ZONING AND PLATTING COMMISSION SITE PLAN REVIEW SHEET  
ENVIRONMENTAL VARIANCE REQUEST ONLY  
REVIEW SHEET

**CASE:** SP-2013-0110D

**PROJECT NAME:** 15101 Debba Drive

The site has already constructed fill over a portion of the tract with depths ranging from 0.5 feet to approximately 9.5 feet over the allowable 4 ft. The variance is to allow fill in excess of 4', but not to exceed 14' (LDC 25-8-342 (A)).

## **BACKGROUND**

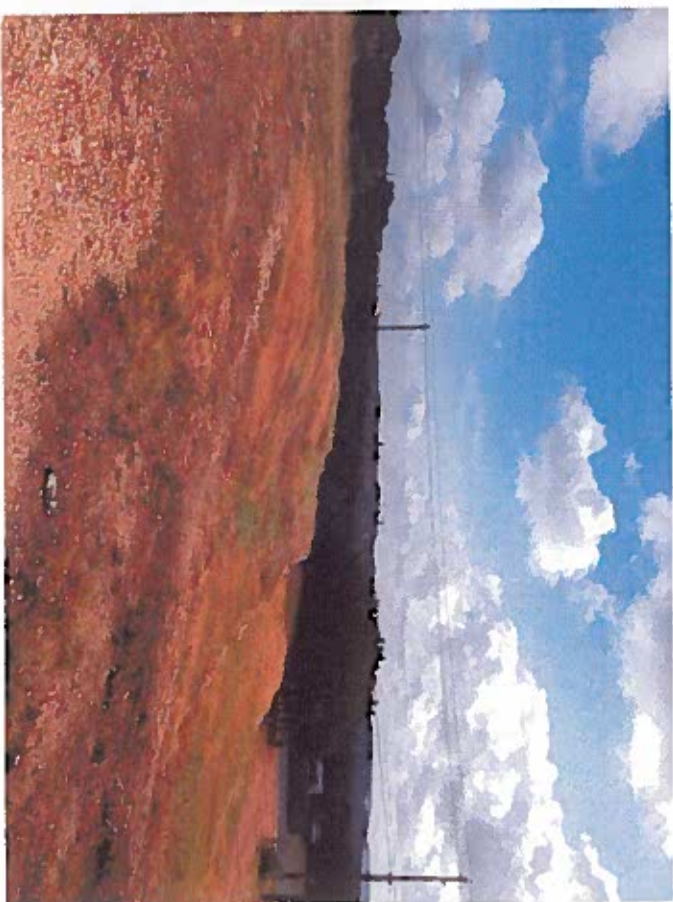
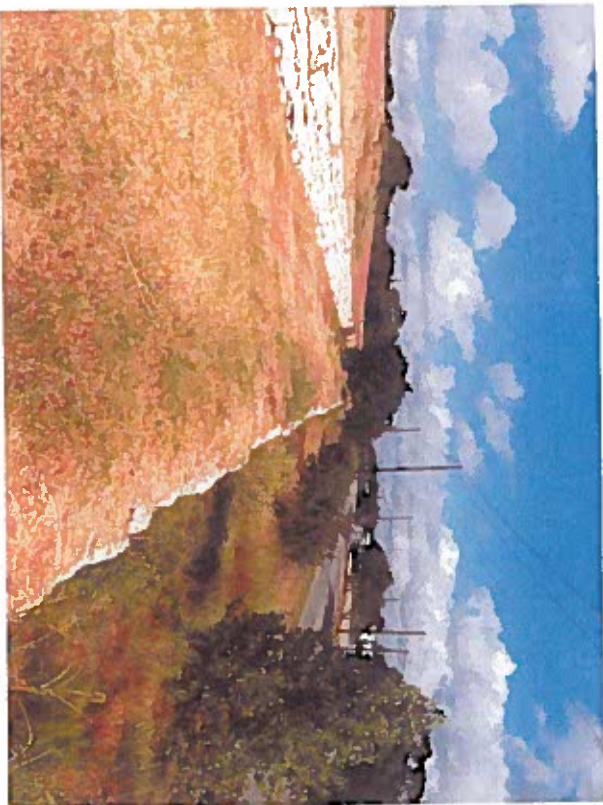
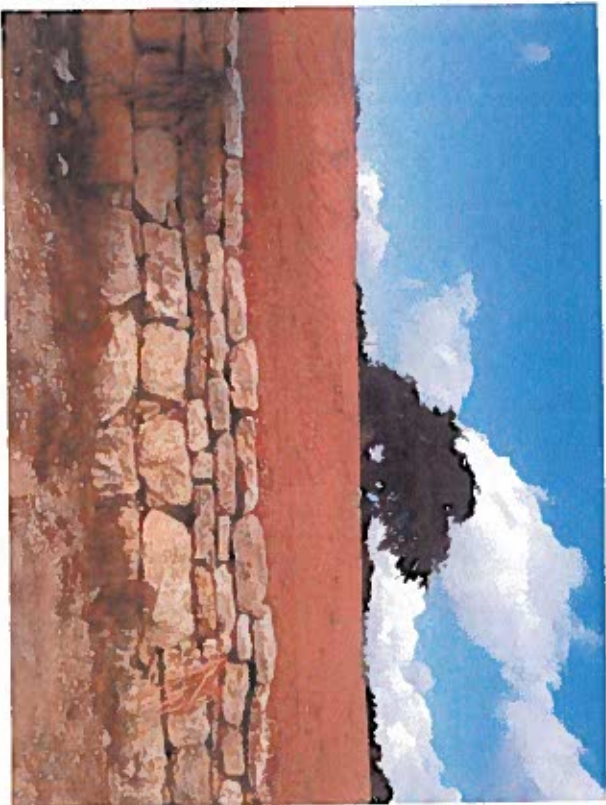
Applicant says he obtained basic development permit from Travis County and did not know about CoA regulations.

Fill exceeds 13' in height and is partially located in the required 40% buffer area.
